**TOWN OF NEWBURGH
PLANNING BOARD
TECHNICAL REVIEW COMMENTS**

PROJECT NAME: ADS PROPERTIES CAR WASH
PROJECT NO.: 2021-04
PROJECT LOCATION: SECTION 95, BLOCK 1, LOT 14.1
REVIEW DATE: 10 NOVEMBER 2023
MEETING DATE: 16 NOVEMBER 2023
PROJECT REPRESENTATIVE: PIETRZAK & PFAU

Re: ADS Properties, LLC Carwash
PB Project No. 2021-04
P&P No. 31102.01

Plans have been revised in accordance with the January 28, 2022 MH&E comment letter, the January 3, 2022 Creighton Manning comment letter, and the November 12, 2021 KALA comment letter. The following are responses to the provided comments:

PROPOSED VEHICLE STACKING PLAN

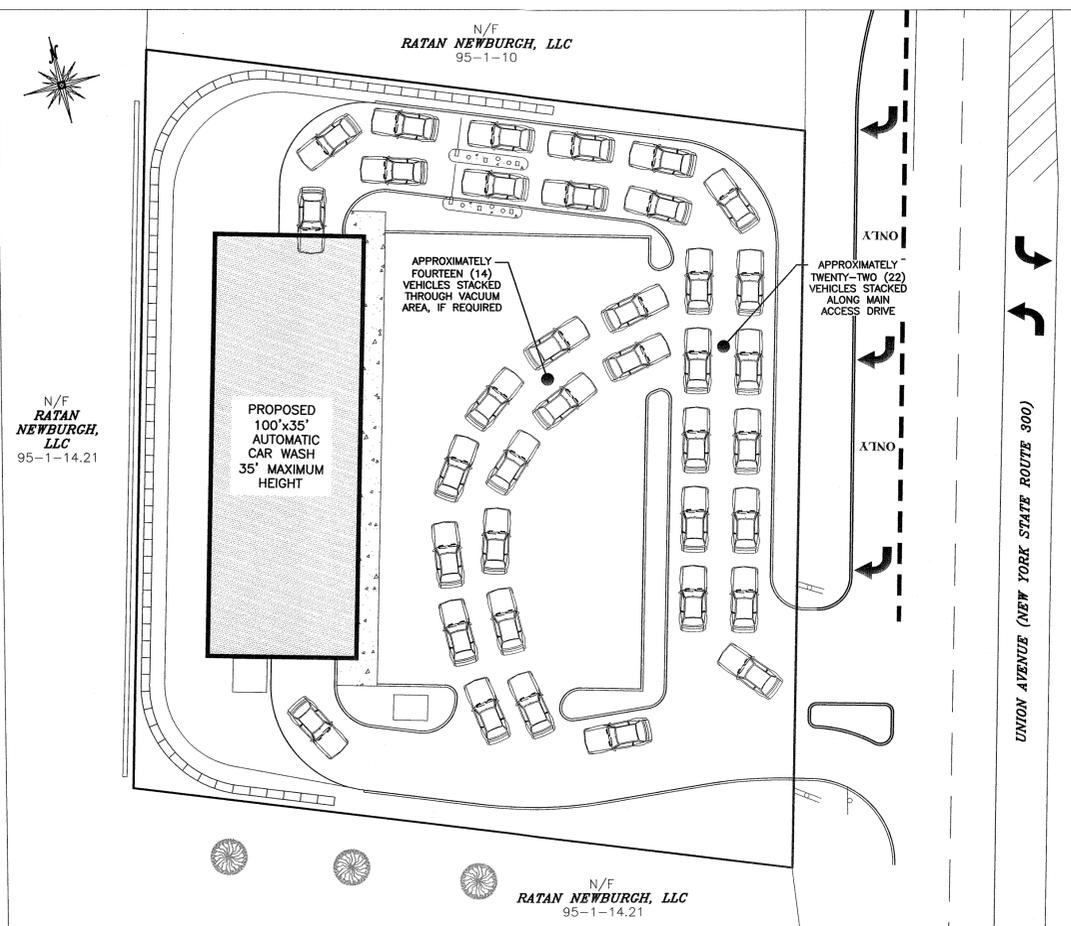
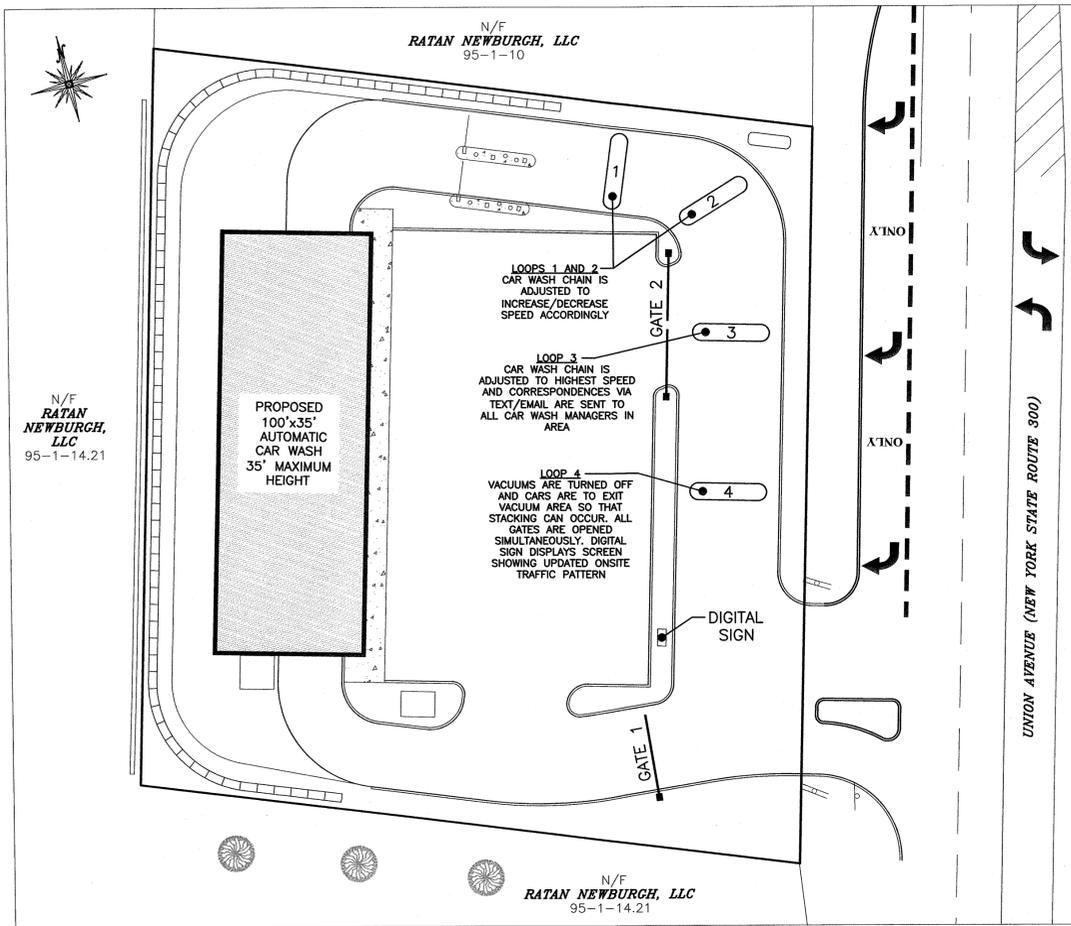
1. The proposed Vehicle Stacking Plan on Drawing #9 has been updated to show the systems as specified in the Helios Engineering Automated Stacking Letter dated June 2, 2021.

2. The approval email from the NYSDOT Traffic and Safety Group has been provided with this submission.
3. The day-to-day traffic management will consist of mostly the conveyor belt speed in the car wash varying with the demand. This process will happen automatically as sensors throughout the queue line detect the status of vehicles in specific locations and send the information to the conveyor system. On a busy day, as the queue line increases, the conveyor belt will increase as well to process cars faster. Additionally, if the electrical automation system in the queue detects that the queue is stacking too fast, and the conveyor belt cannot keep up, an attendant will direct cars out of the vacuum area to allocate space for additional stacking. Signage at the entrance will then be automatically switched to direct cars to the vacuum area for additional stacking as shown on the Vehicle Stacking Plan on Drawing #9.
